REPORT TO THE LAKES VEGETATION AND LANDSCAPING COMMITTEE

To:	The LVL Committee	FOR:	11/12/2020 LVLC meeting.
VIA:	Carlos Dougnac, Assistant Vice President, PDC	FROM:	Jim Vignola, PDC, Project Manager
REQUESTOR:	FLMNH	PRESENTERS:	Jim Vignola, PDC PM and User Group

PROJECT:
UF-373, FLMNH - Special Collections Building

FLMNH - Special Collections Building

Landscaping Impacts, Cont.

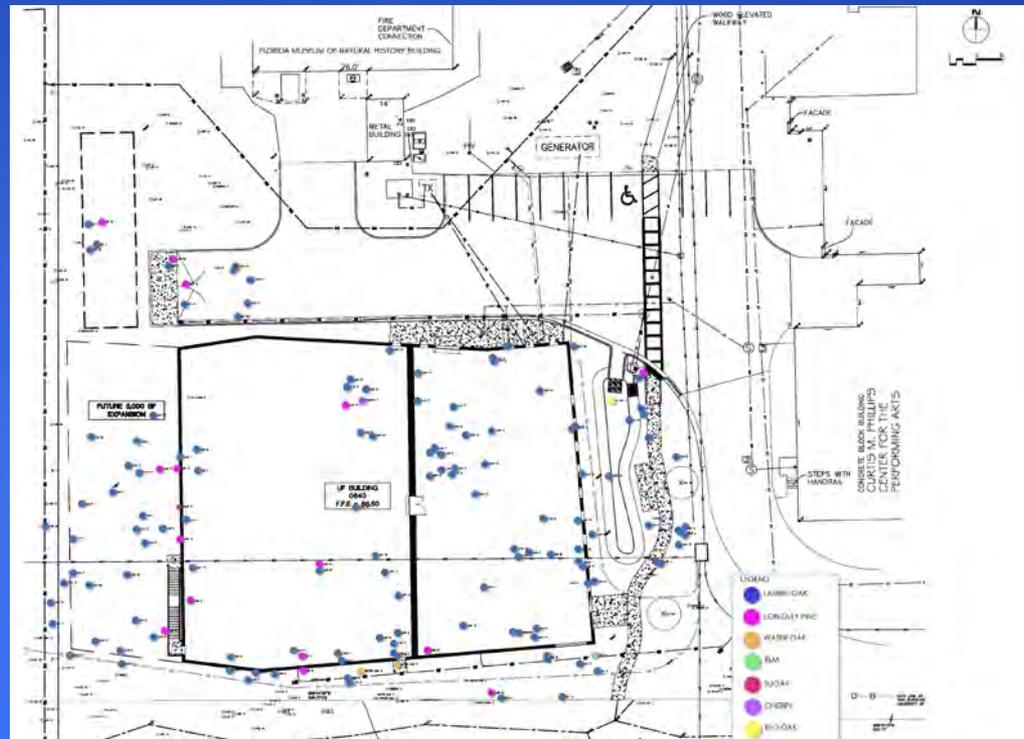
- Address Past Comments
- Move or remove building sign and add sign for NATL
- Consider an abstract design on the Entrance Wall of the building

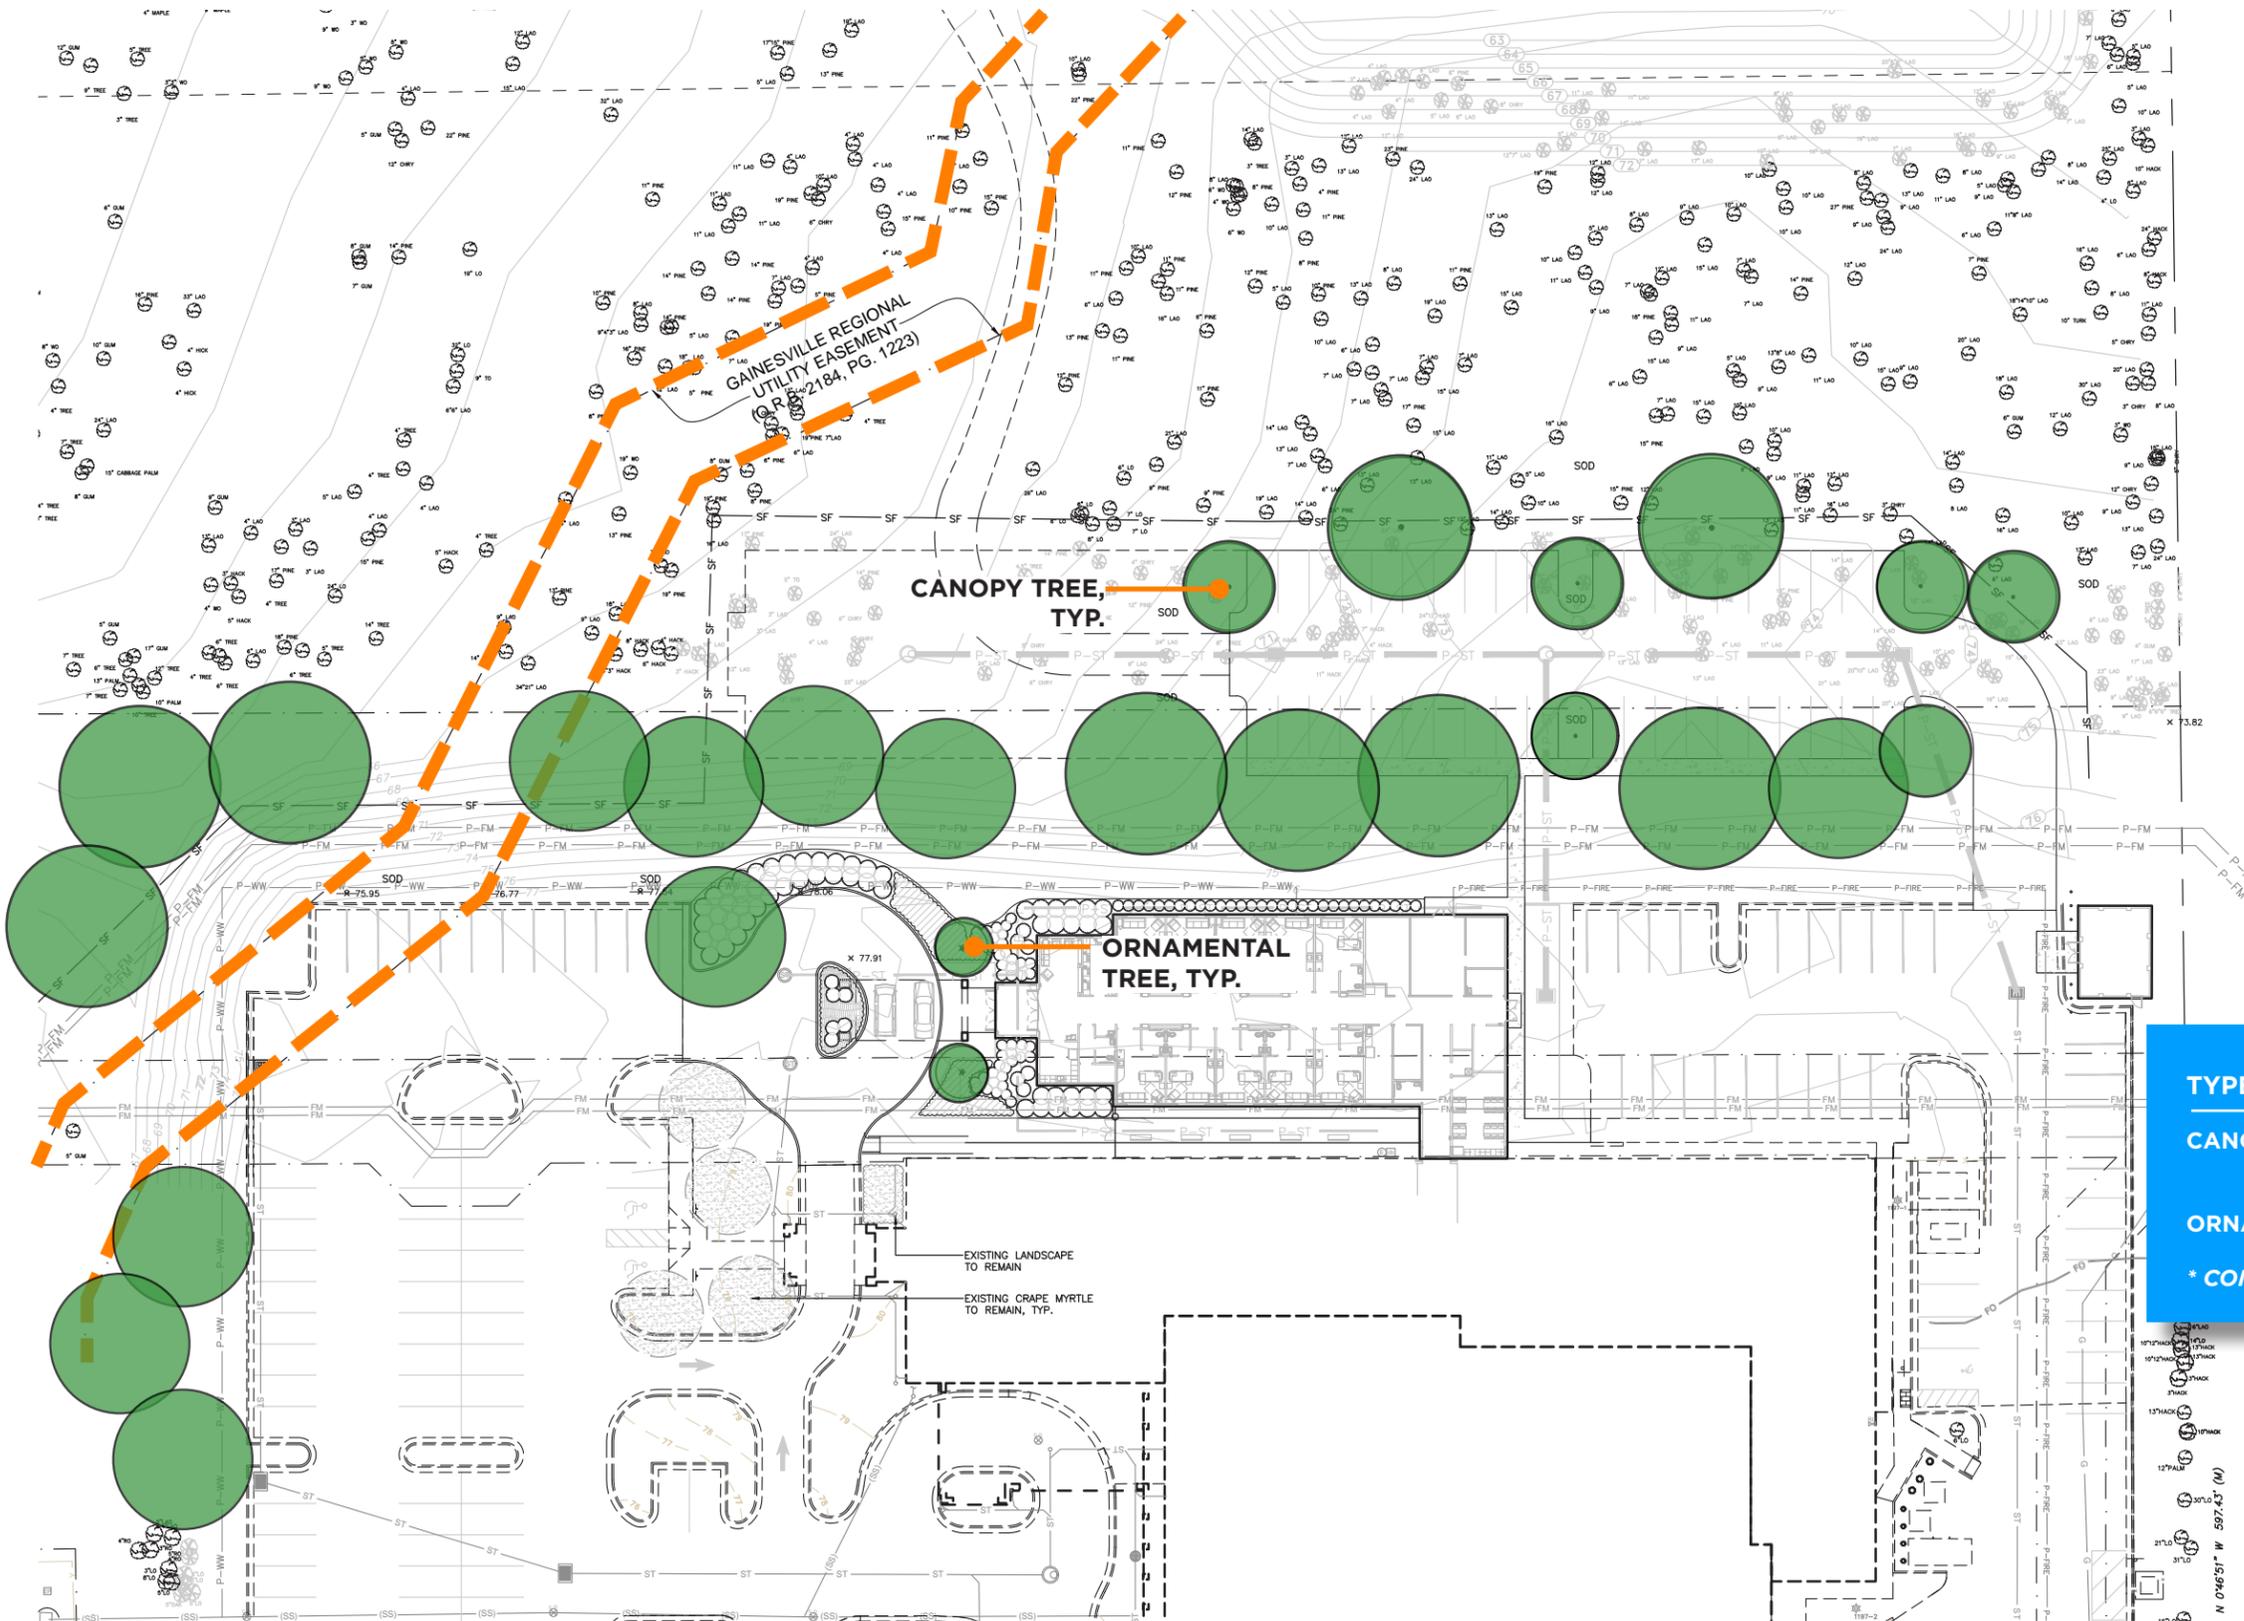
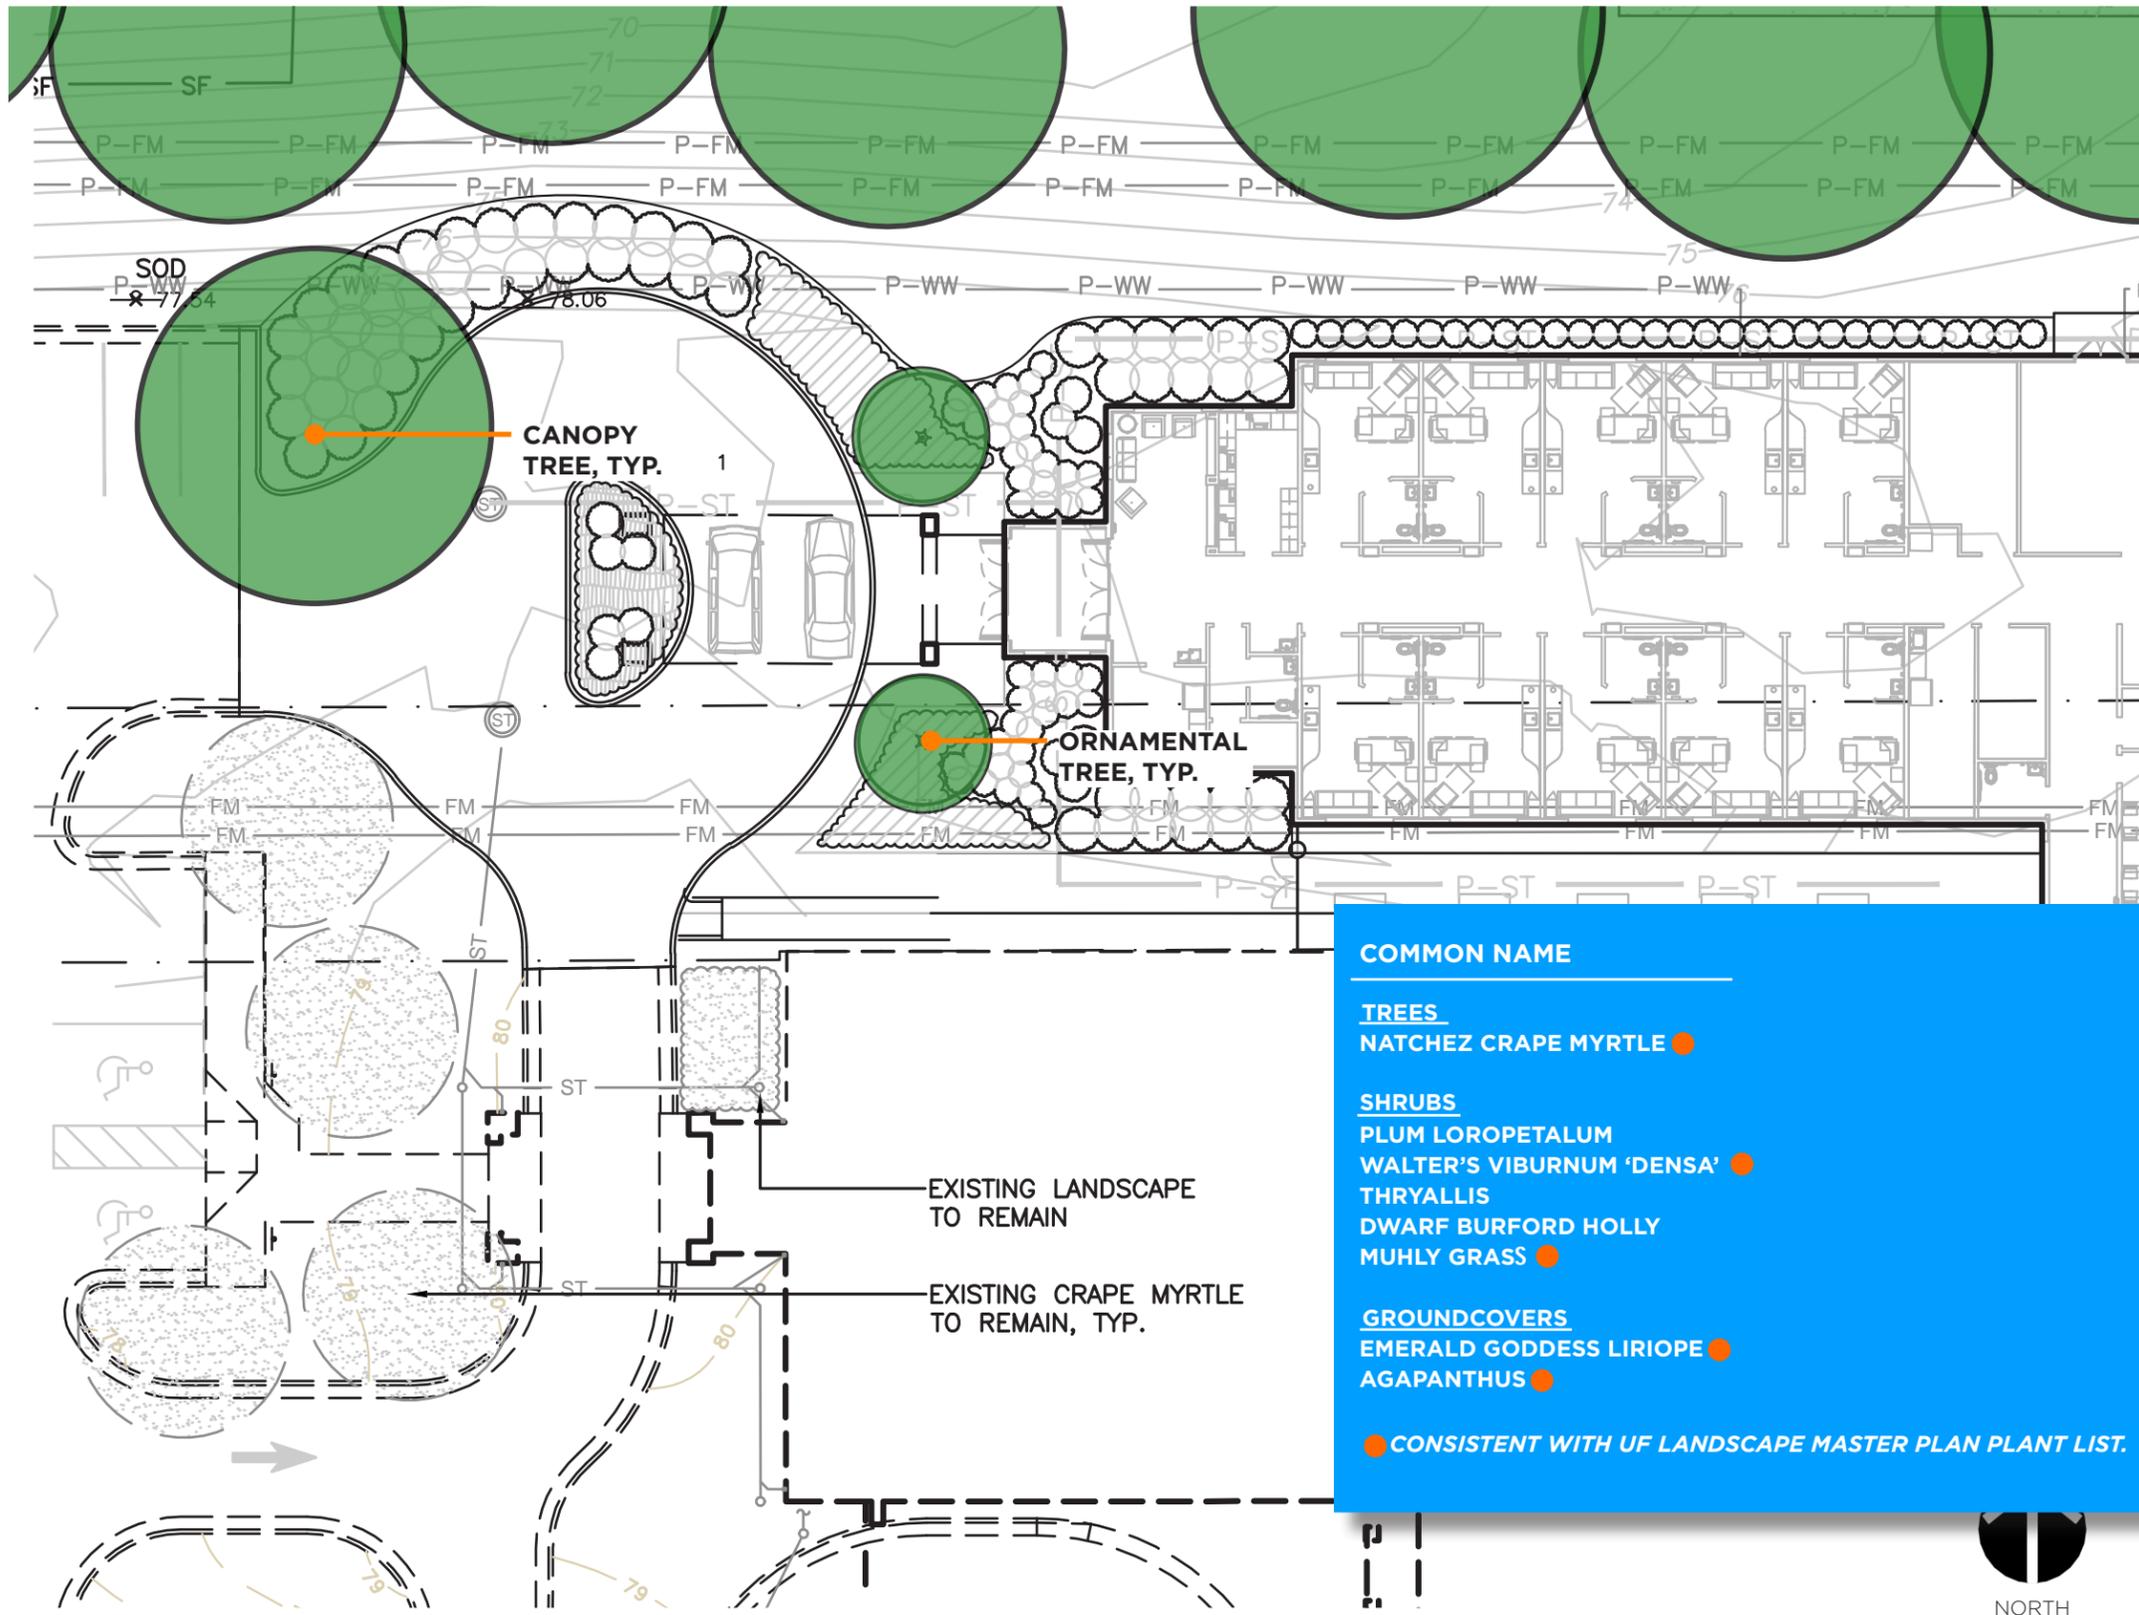
- Qty of tree demo: The number of trees being removed in the footprint of the 'future' addition. Do all of those need to come down now? Or is it a factor of cranes and tilt-up space too? If we can save some, that's good for Mitigation budget and LVL Committee. If not, explain why.

- Address Past Comments
- Controlled Burns: TLC will address in the Basis of Design “Sequence of Operations”. It will include ember screens and smoke detectors.
- Qty of tree demo: Carefully considered construction impact and space.
- No Palm Trees and DO remove undesirable trees/shrubs.
